# UNITED STATES PATENT AND TRADEMARK OFFICE

10/572,378

<b>Office Action Summary</b>	<b>Application No.</b> 10/572,378	<b>Applicant(s)</b> KOIZUMI ET AL.	
	<b>Examiner</b> MAHBUBUR RASHID	<b>Art Unit</b> 3683

## **DETAILED ACTION**

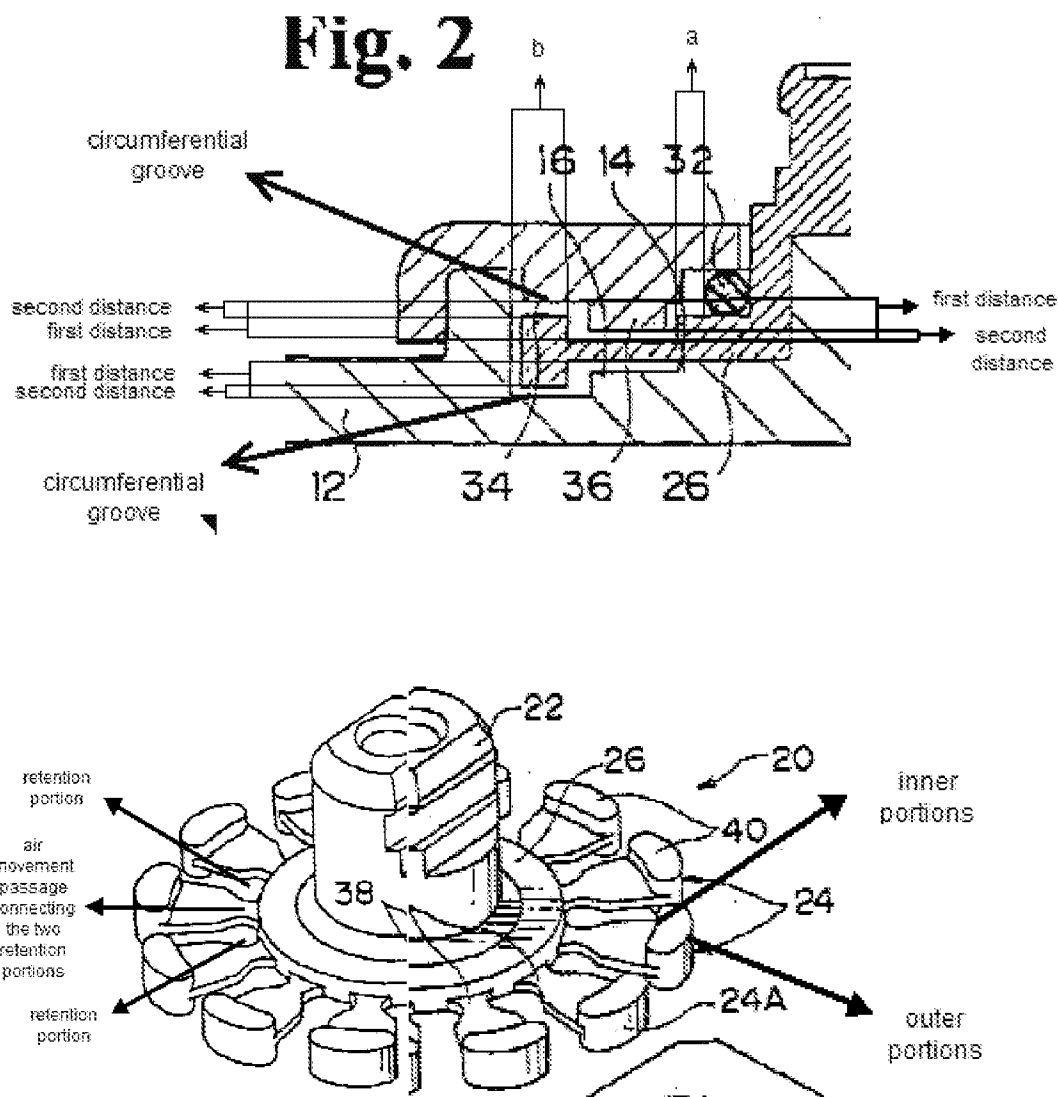
Regarding claim 14, in line 2, “an inner side of the resistive portion” – is not clear and not disclosed in the specification exactly which side of the resistive portion the applicant is referring it to as the inner side of the resistive portion.

Regarding **claims 1 and 3-14**, Hayashi discloses all claimed elements set forth in the figures above and the last office action mailed on 01/15/2008, but Hayashi does not disclose a smooth outer periphery of the rotor extending continuously without interruption, but Sugasawara discloses a damper device (figs. 5a-5d) with a rotor (6) having a smooth outer periphery extending continuously without interruption. It would have been obvious to one of ordinary skill in the art at the time the invention was made to make the rotor of Hayashi having a smooth outer periphery extending continuously

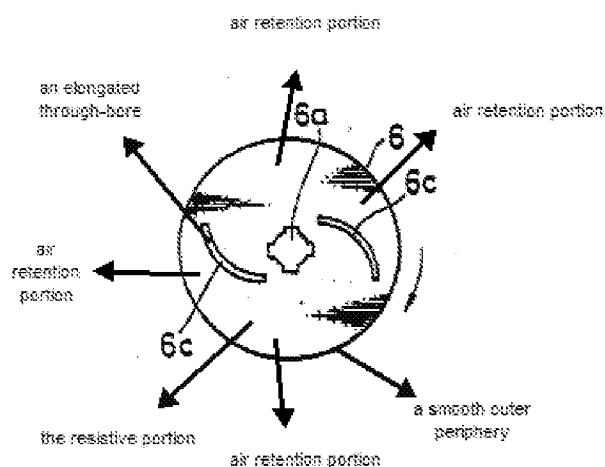
Hayashi does not disclose the arc shaped air retention portions being formed by elongated through-bore as claimed, but Sugasawara discloses a damper device (figs. 5a-5d) with a rotor (6) having an arc shaped air retention portions (see figure below) being formed by elongated through-bore (6c). It would have been obvious to one of ordinary skill in the art at the time the invention was made to make the disc of Hayashi with the arc shaped air retention portions being formed by elongated through-bore as taught by Sugasawara, because the arc shaped air retention portions being formed by elongated through-bore will accelerate the flow of viscous liquid to ensure a smooth movement of viscous liquid.
